**Working draft of a new 07 series of amendments to UN
Regulation No. 10**

Modifications highlighted in yellow: under discussion within IWG-EMC

Modifications highlighted in green: agreed within IWG-EMC

07 series of amendments to UN Regulation No. 10 (Electromagnetic compatibility)

Figure 2
Position of antenna in relation to the vehicle:

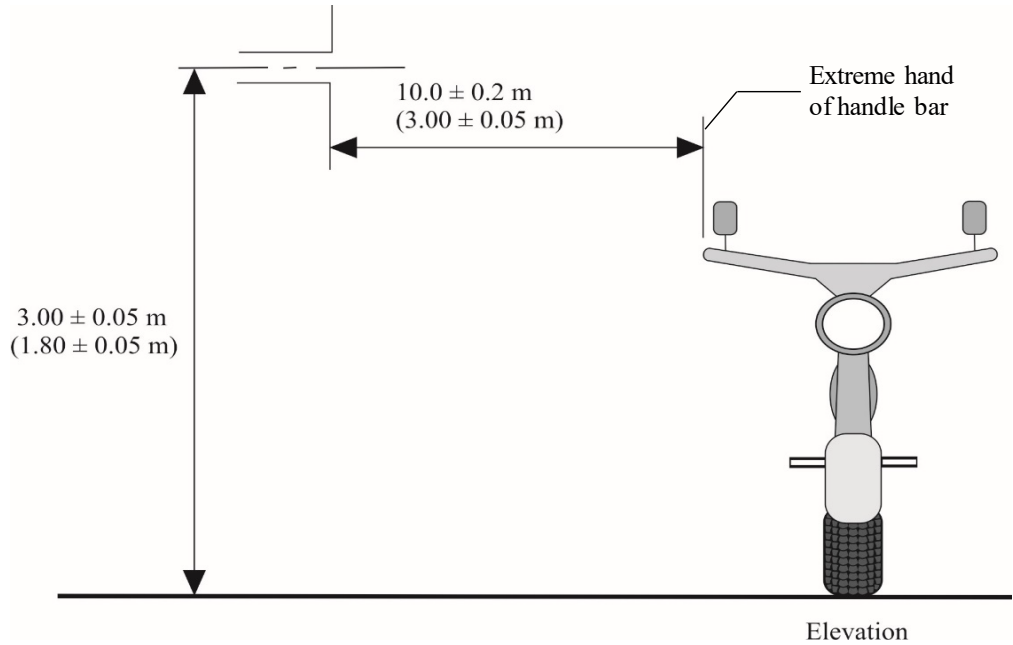
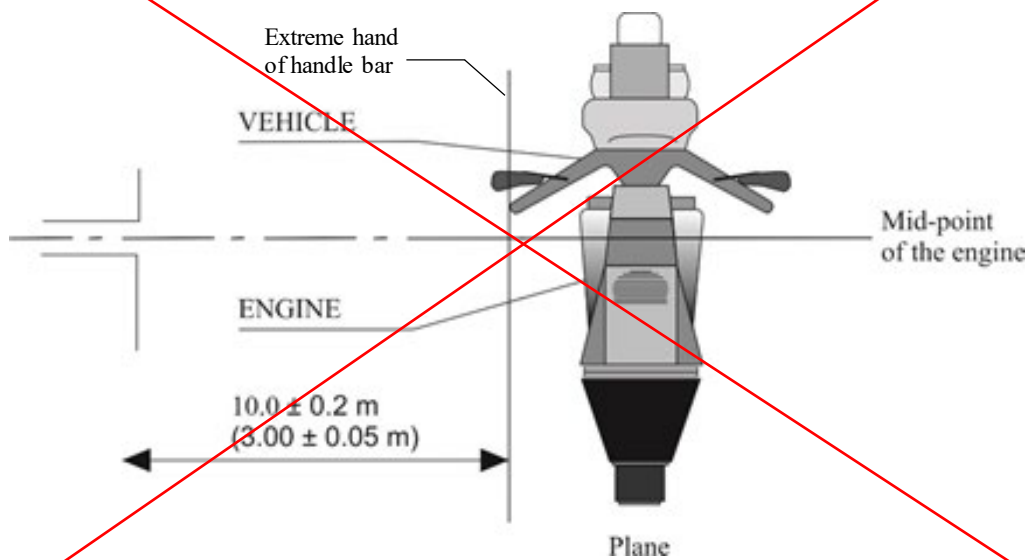
~~Figure 2a
Dipole antenna in position to measure the vertical radiation components~~

~~Figure 2b
Dipole antenna in position to measure the horizontal radiation components~~
